## **PUBLIC COMMENTS REPORT**

### **CAMDEN COUNTY UNIFIED DEVELOPMENT ORDINANCE**

**November 8, 2018**

This report is being provided to present comments received from the public either through individual conversations or notes from review committees on the proposed revised Unified Development Ordinance (UDO). Several very helpful comments have been received and many of them incorporated into the proposed draft of the UDO or the concern resolved. Those comments are not included in this report. Other comments not included are those that were discussed and decisions made during the Planning Board/Board of Commissioners' work sessions with the results being included in the proposed UDO. Every effort has been made to document comments received, however it may not reflect every single one. In all cases staff has encouraged the public to participate at the public hearing.

**5.14.11 SIGN STANDARDS IN COMMERCIAL DISTRICTS**

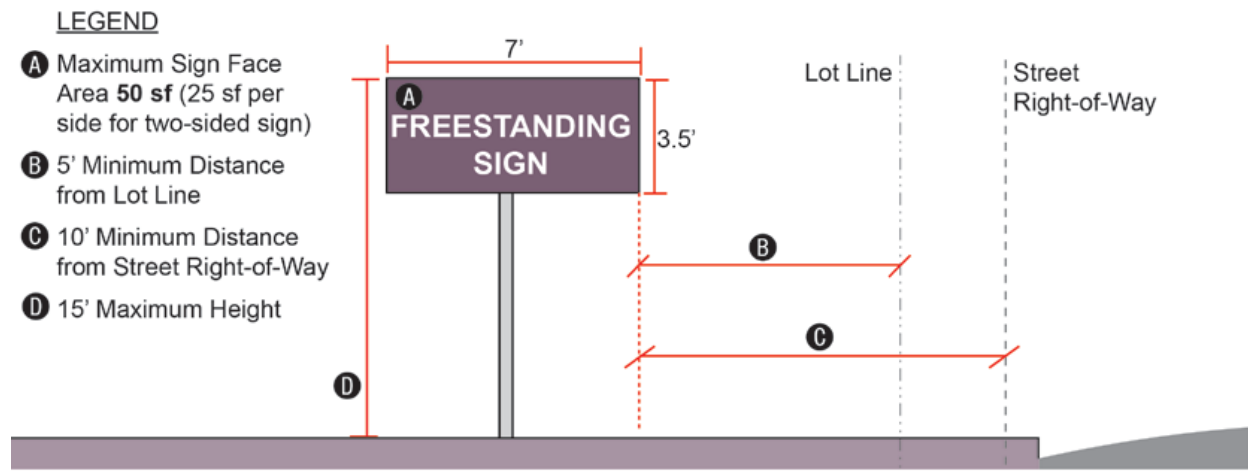
Both wall signs and free standing signs are critical for businesses to attract customers and should be allowed additional sign face square feet.

Free standing pole signs should not be permitted at all.

*Staff generally agrees with the proposed standards, particularly in the mixed use and residential districts. It is recommended that for commercial districts the sign face standards be slightly increased. The recommendations are based significant research following the thorough discussion during the PB/BOC work sessions, specifically a joint research report Street Graphics and the Law written by two experts recognized by both the American Planning Association and the Sign Industry. (See attached staff research)*

**Recommendation:** for Commercial District are

- Increase allowable wall sign face to 1.5 Sq. Ft. per 1 linear foot façade
- Increase allowable free standing sign face to 100 Sq. Ft (50 per side)
- Up to 6 tenants 150 sq. ft. (75 per side)
- 7-14 tenants 200 sq. ft. (100 per side)
- 15 plus tenants 250 sq. ft. (125 per side)
- Increase height limitation to 20 feet.
